**CITY PLAN COMMISSION****THURSDAY, AUGUST 22, 2024****FILE NUMBER:** S234-166**SENIOR PLANNER:** Hema Sharma**LOCATION:** Garden Grove Drive, north of Ravenview Road**DATE FILED:** July 25, 2024**ZONING:** R-10(A)**CITY COUNCIL DISTRICT:** 8**SIZE OF REQUEST:** 2.090-acres**APPLICANT/OWNER:** John P. Flores

**REQUEST:** An application to create two 1.045-acre lot from 2.090-acre tract of land in City Block 8830 on property located on Garden Grove Drive, north of Ravenview Road.

1:2,400	<p><b>EXISTING AREA ANALYSIS MAP</b></p> <p><input type="checkbox"/> Area of Request</p> <p><input type="checkbox"/> Recent History</p>	<p>Case no: <b>S234-166</b></p> <p>Date: <b>8/2/2024</b></p>
--	---	--

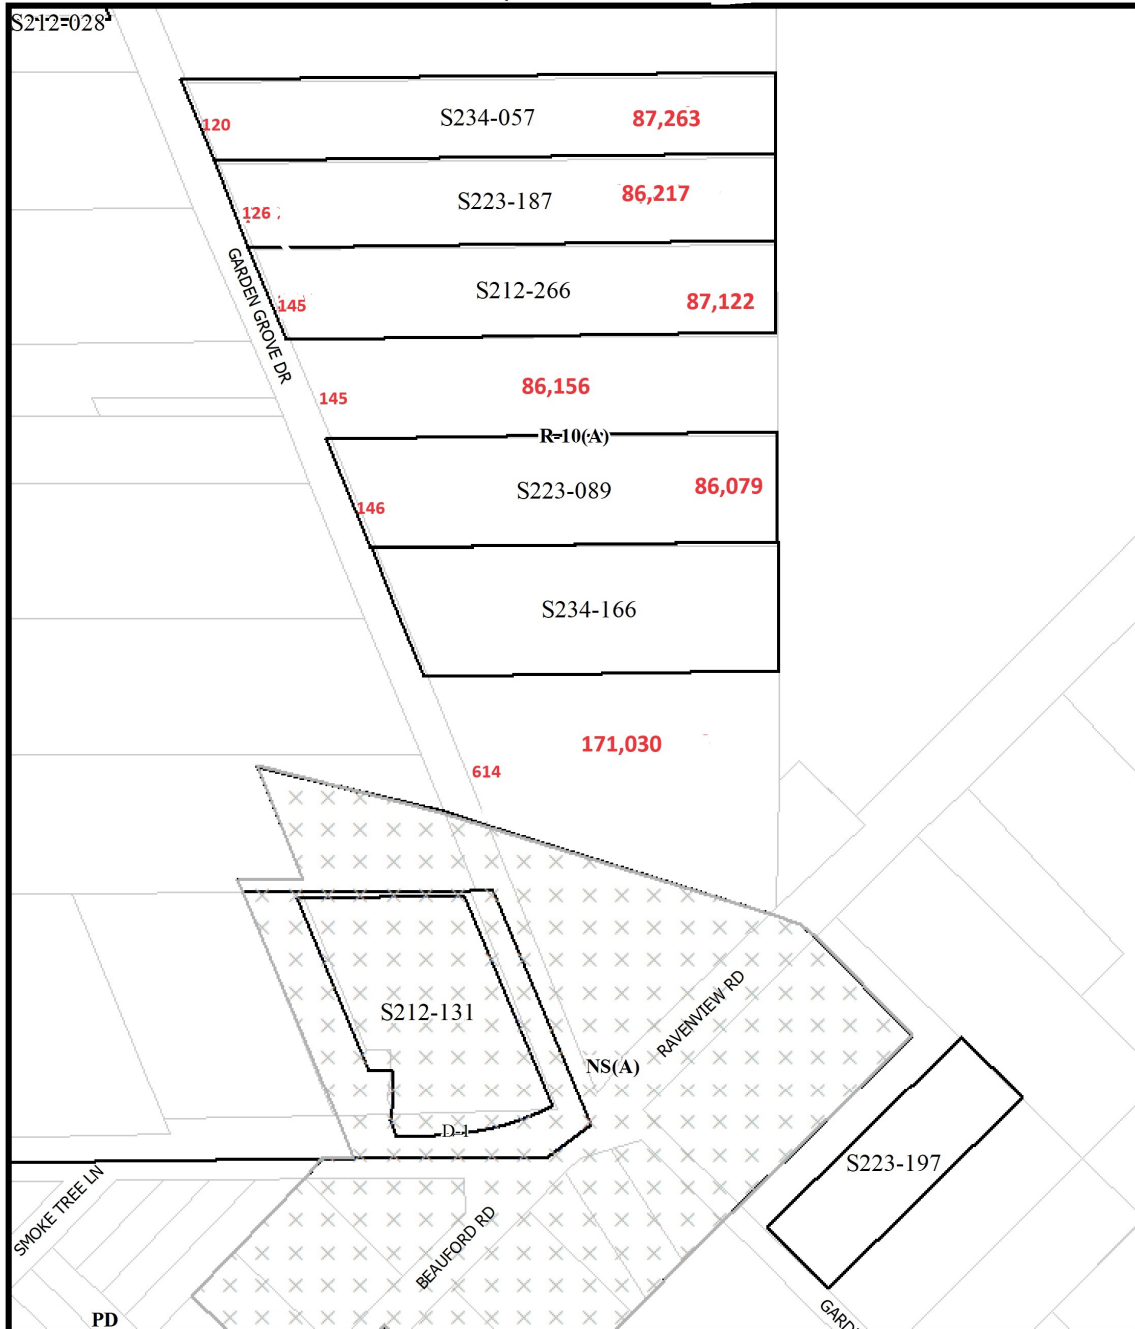
- The properties on eastline of Garden Grove Drive are ranging in areas from 86,079 square feet to 171,030 square feet and widths are ranging from 120 feet to 614 feet and are zoned the R-10(A) Single Family District. *(Please refer to the existing area analysis)*

The request is to create two lots 1.045-acre (45,541 square feet) and lot widths are 97.91 square feet and 91.19 square feet and are zoned R-10(A) Single Family District.

Staff concludes that there is not an established lot pattern in the immediate area of the request and the request complies with the requirements of Section 51A-8.503 and R-10(A) Single Family District; therefore, staff recommends approval of the request subject to compliance with the following conditions:
